Comment i-31:

Single PMD w/ optional RS-FEC

Yasuo Hidaka (yasuo.hidaka@us.fujitsu.com)
Fujitsu Laboratories of America, Inc.

January 18-19, 2016

Figure 73–11—Arbitration state diagram

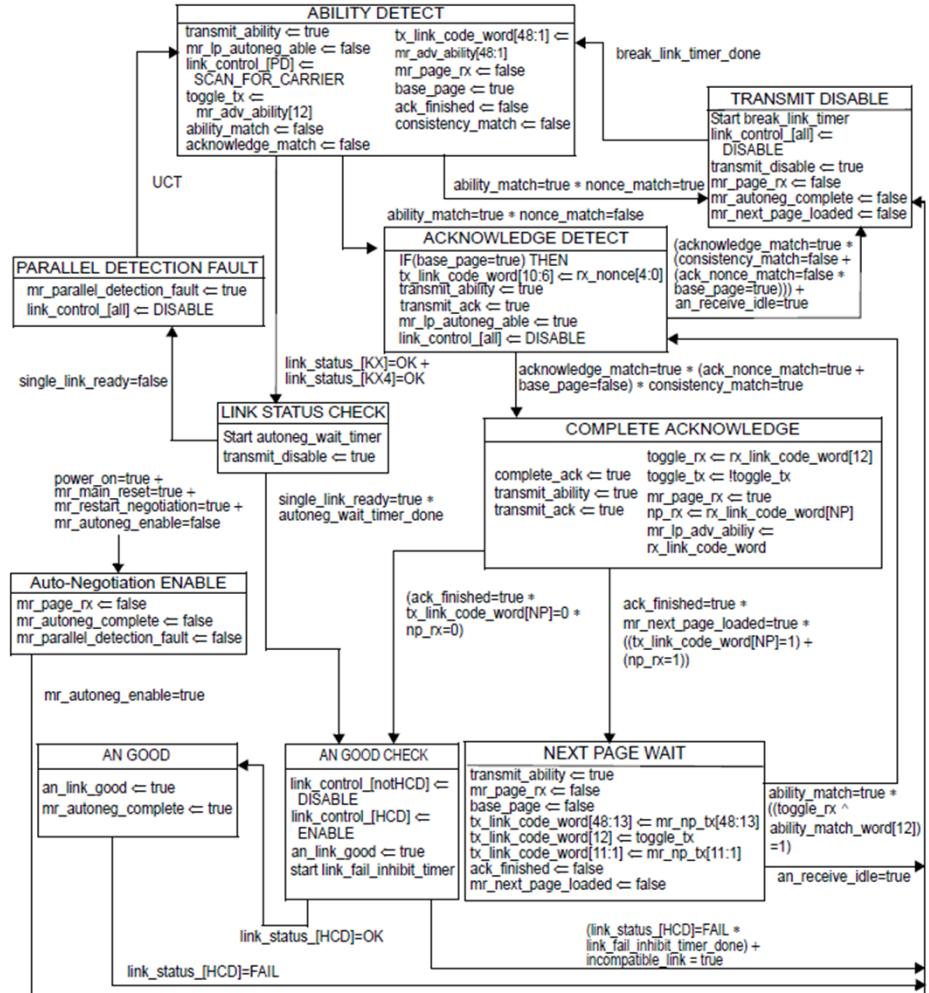
- AN in Clause 73 never fails due to 10G FEC-mode resolution
 - 10G FEC-mode resolution always succeeds
 - F0 : 10G FEC ability
 - F1 : 10G FEC requested
 - AN fails only if there is no HCD (Highest Common Denominator) of PMDs at two ends of the link
- With option 3, AN now may fail due to FEC-mode resolution
 - AN may fail if “RS-FEC required” cannot be satisfied
 - We may have to change AN state diagram shown on right
 - I do not want to do this. Anybody?
